**World Forum for Harmonization of Vehicle Regulations****Working Party on Lighting and Light-Signalling****Eighty-fourth session**

**UN Regulation No. 48 (Installation of lighting and light-signalling devices):****Proposals for new series of amendments to UN Regulation No. 48****Proposal for a new [08] series of amendments to UN Regulation No. 48****Submitted by the expert from Japan\***

Model A

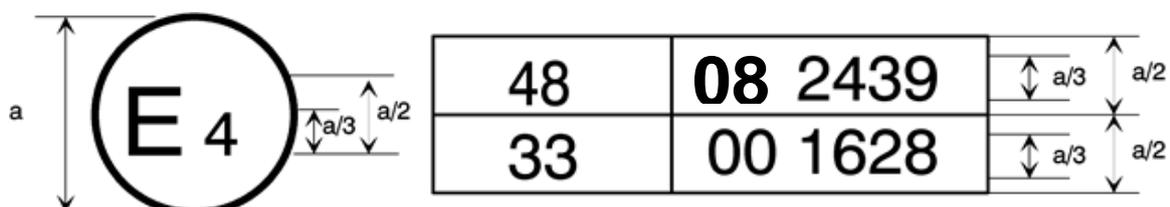
The above approval mark affixed to a vehicle shows that the vehicle type concerned has, with regard to the installation of lighting and light-signalling devices, been approved in the Netherlands (E4) pursuant to UN Regulation No. 48 as amended by the [08] series of amendments. The approval number indicates that the approval was granted in accordance with the requirements of UN Regulation No. 48 as amended by the [08] series of amendments.
